3rd Further Information

**Proposed Temporary Warehouse (excluding Dangerous Goods Godown)
with Ancillary Facilities and Associated Filling of Land for a Period of 3 Years in "Agriculture" Zone,
Lots 136 RP (Part) and 2149 (Part) in D.D. 106 and Adjoining Government Land,
Kam Tin, Yuen Long, New Territories**

(S.16 Planning Application No. A/YL-KTS/1107)

Response-to-Comment (RtC)

FIGURE NUMBER
 FIGURE 4

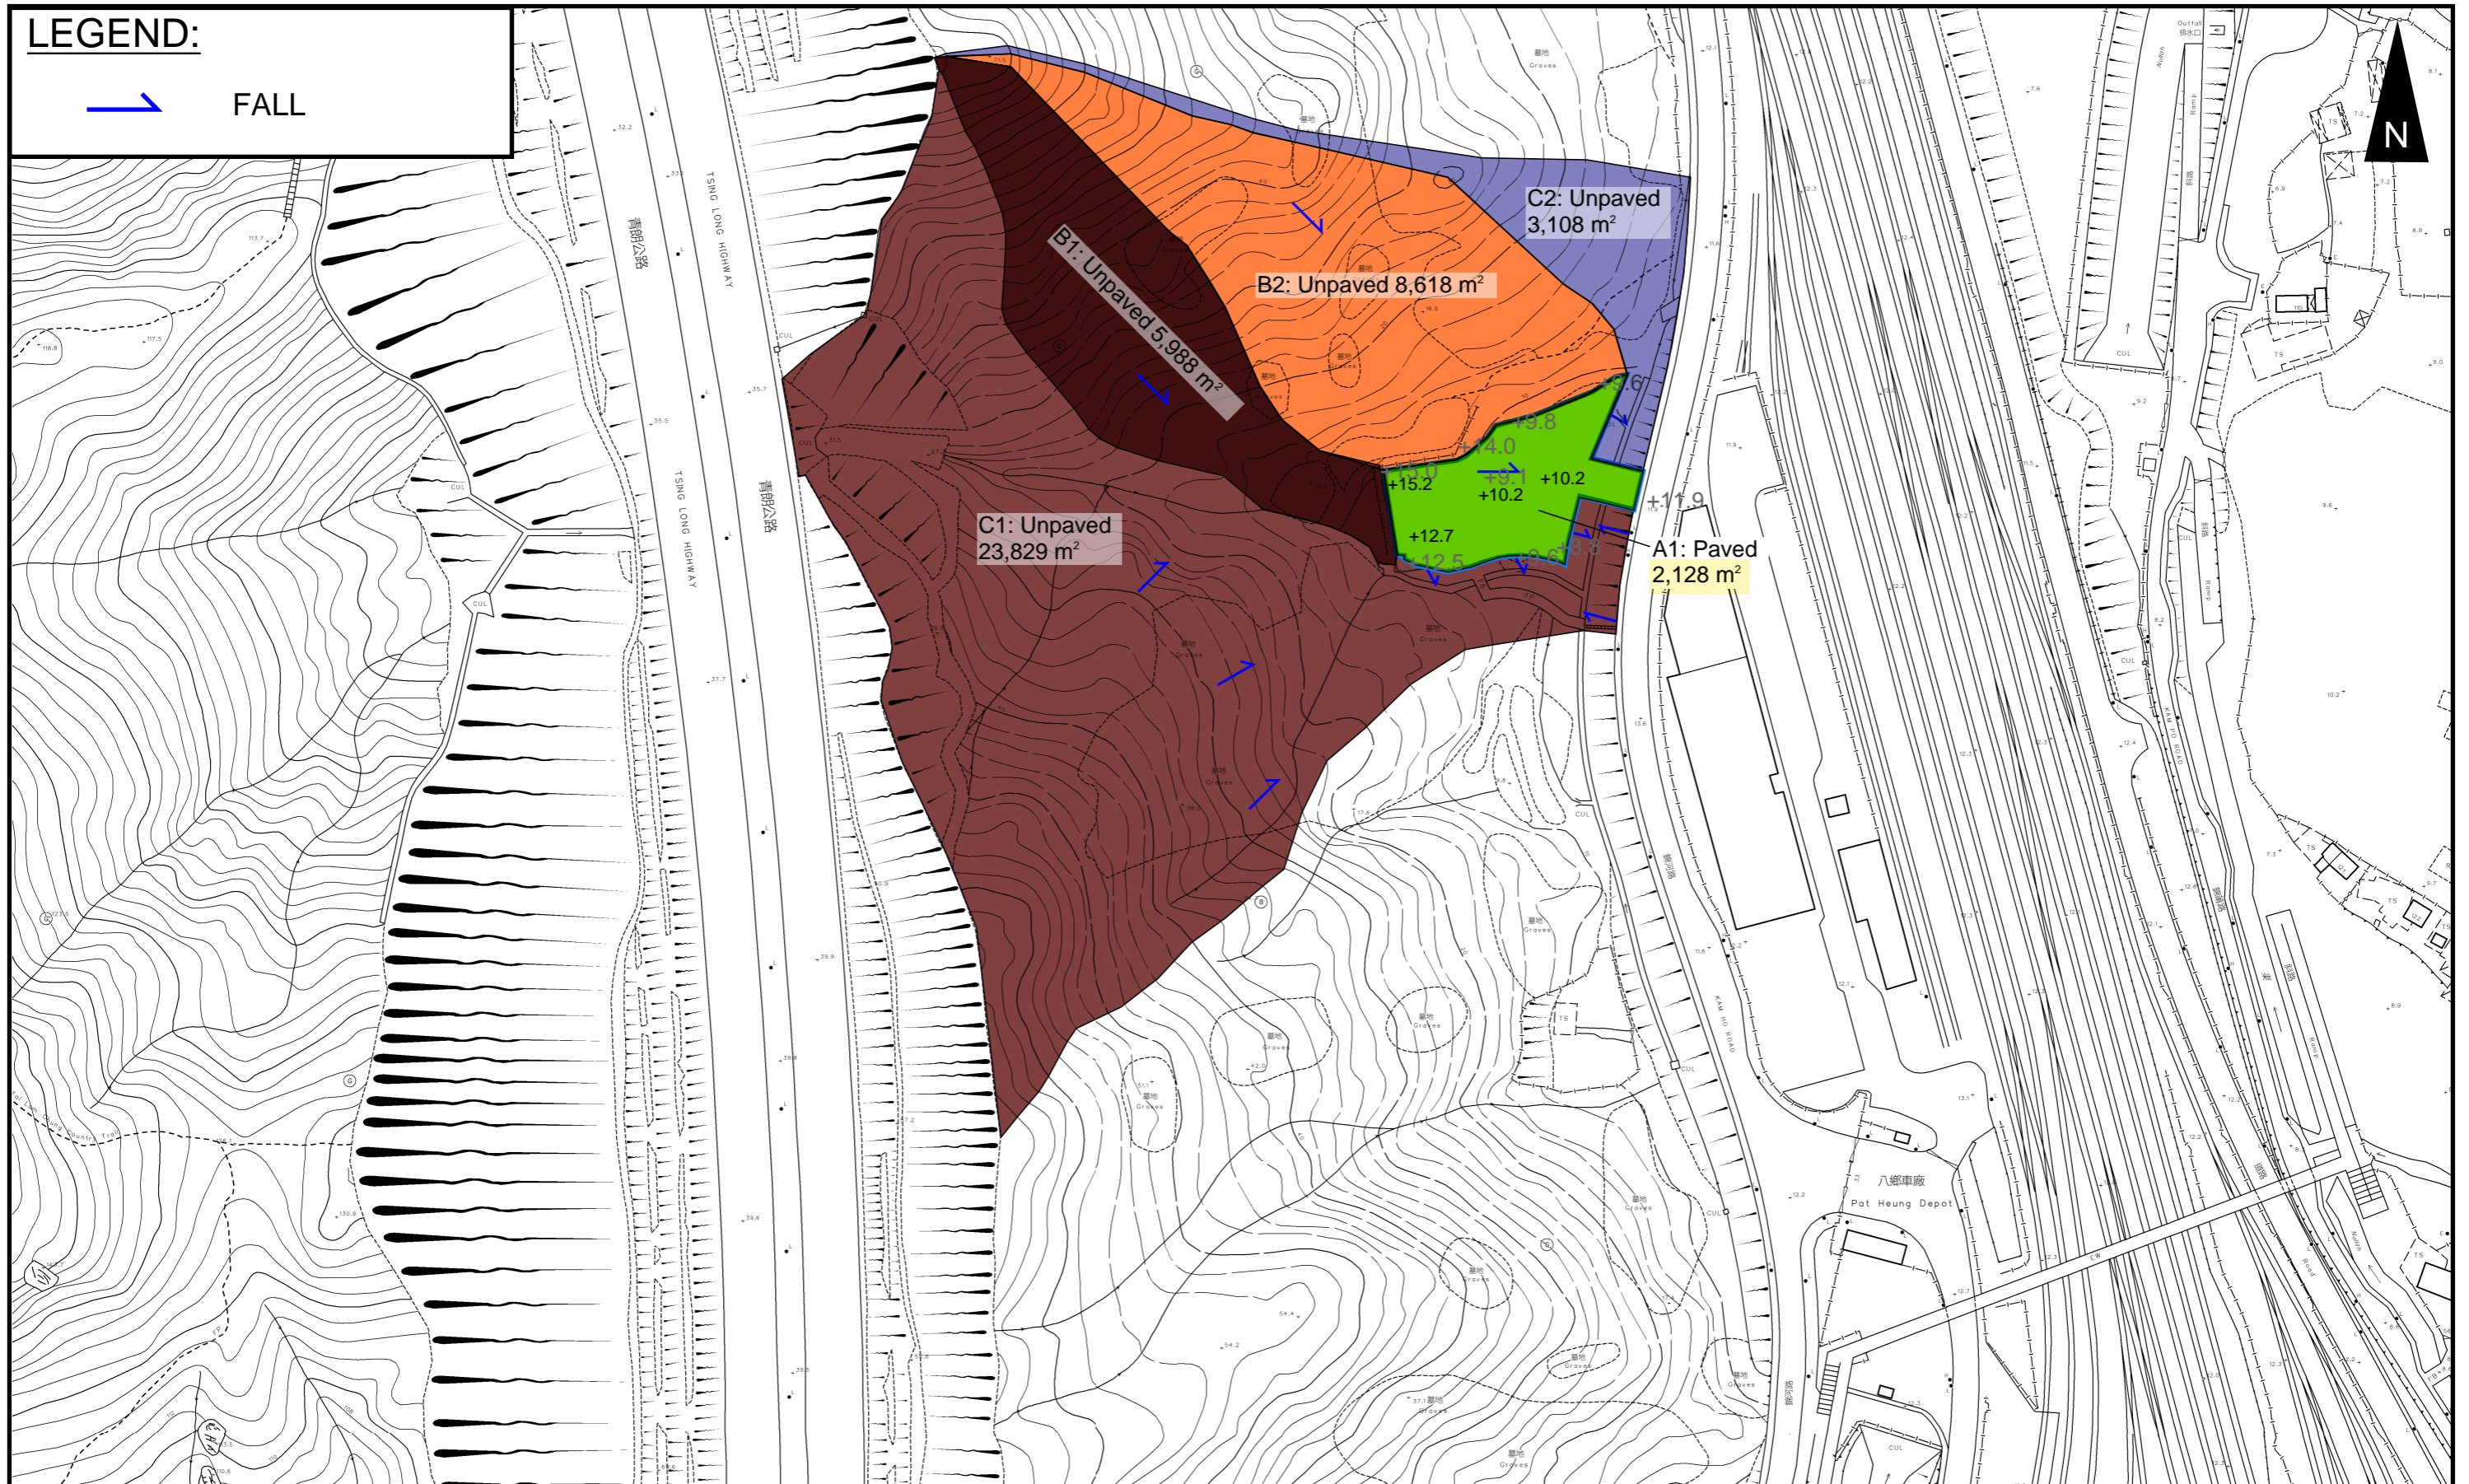
Departmental Comments		Applicant’s Responses
1. Comments of the Chief Engineer/Mainland North, Drainage Services Department (CE/MN, DSD)		
(a)	In view of the existing topography as shown in Figure 4, please make reference to the latest Technical Note No. 1 issued by DSD and upgrade the size of all drainage facilities accordingly.	Noted. Please note that the proposed channels have been designed with consideration of the existing catchments as indicated on Figure 4. The utilisations are about 20% to 62%, which have provided enough capacity. Please refer to the updated drainage proposal at Annex 1 .

FIGURE NUMBER
 FIGURE 5

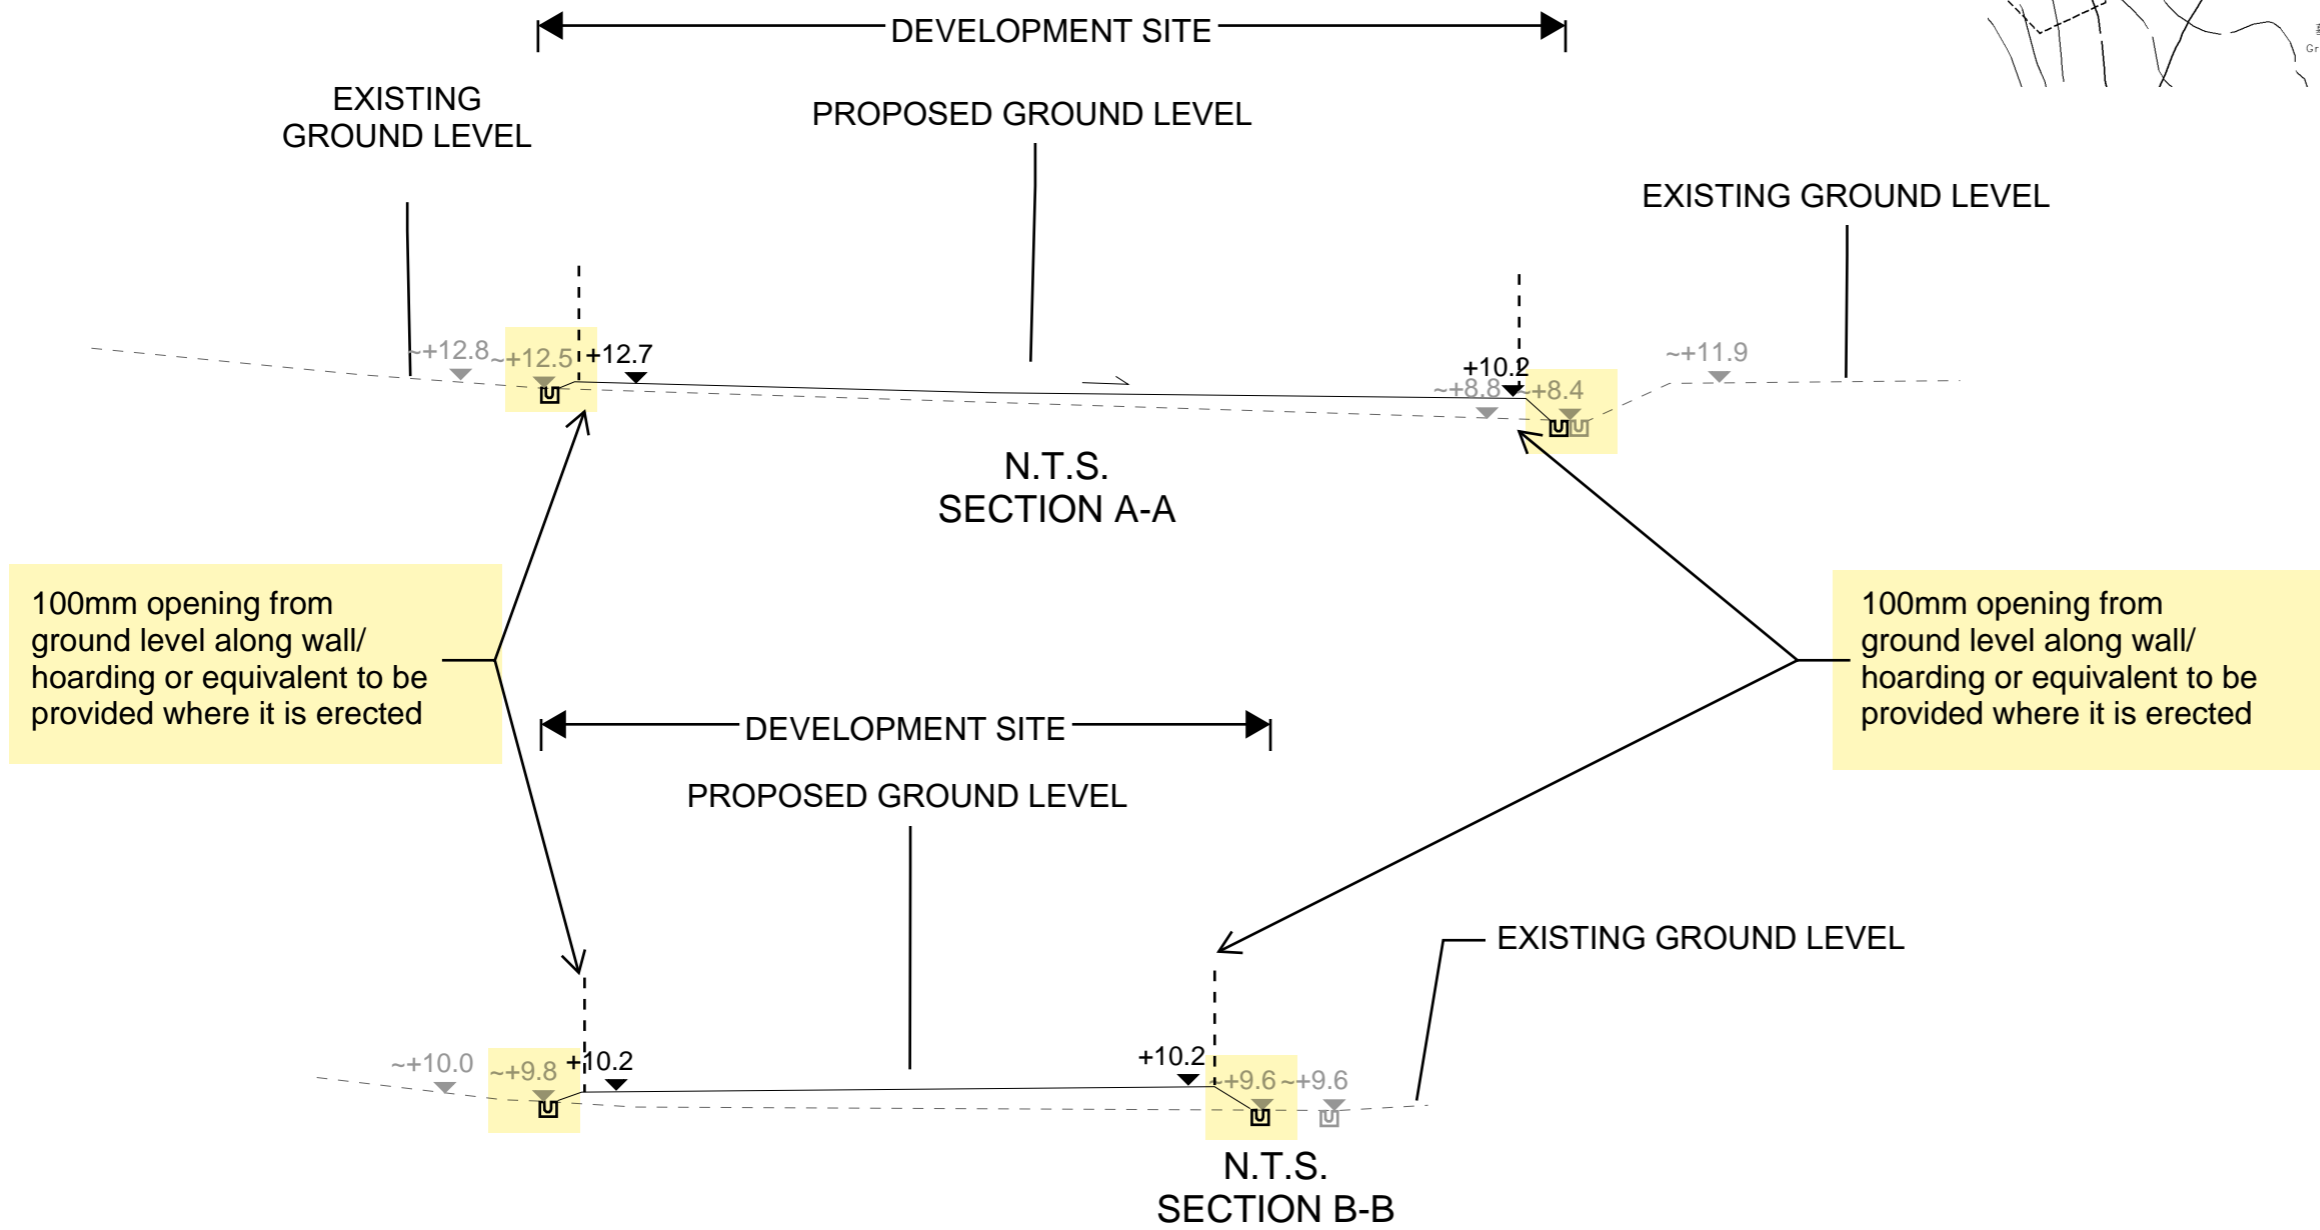
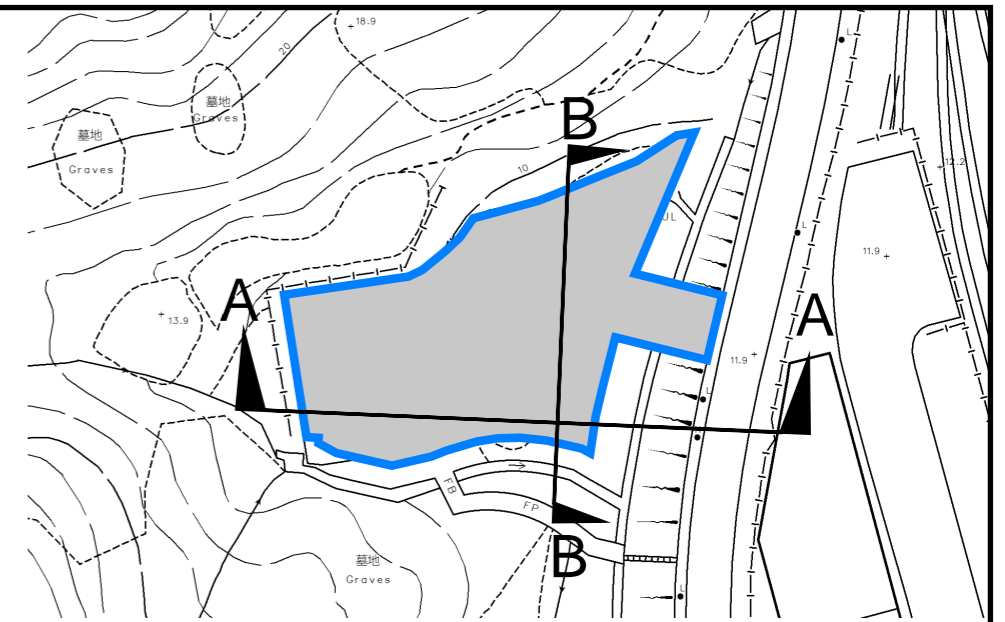
(d)	Please indicate the ground level of the proposed peripheral surface channels as shown in sections A-A and B-B for review. Please be reminded that peripheral surface channels shall be provided along and within the site boundary at the existing/original ground level (instead of the revised ground level) to collect the surface runoff accrued on the application site and to intercept the overland flow from the adjacent lands.	Noted. The ground level of proposed peripheral channels is proposed to match with nearby existing ground level.

SITE PHOTOS

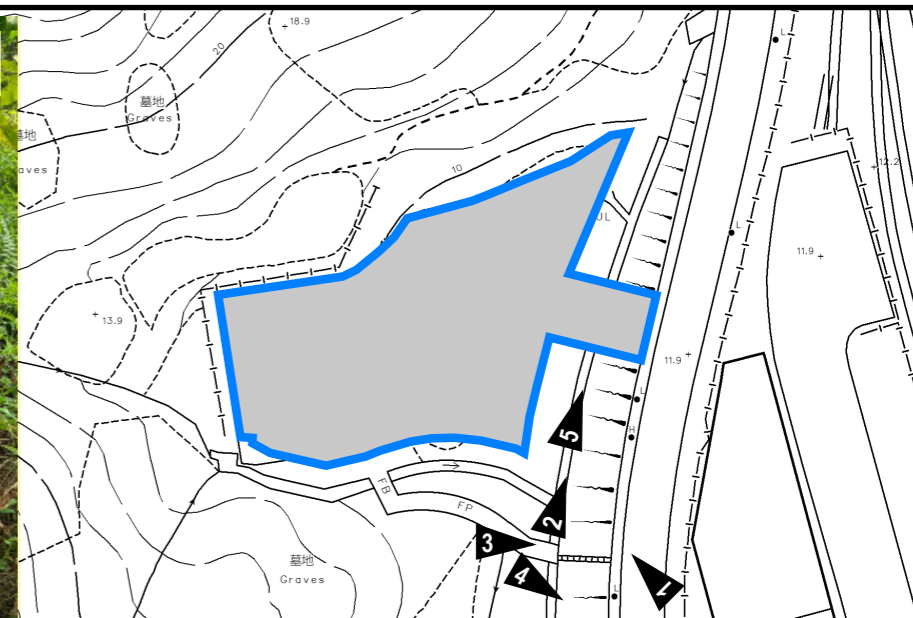
(g)	Please provide more site photos at difference locations and views (i.e. the proposed deck over location, etc.) to show the current condition of the existing 1.7 m channel for review.	Noted. Site photos are enclosed at Appendix D for your review.
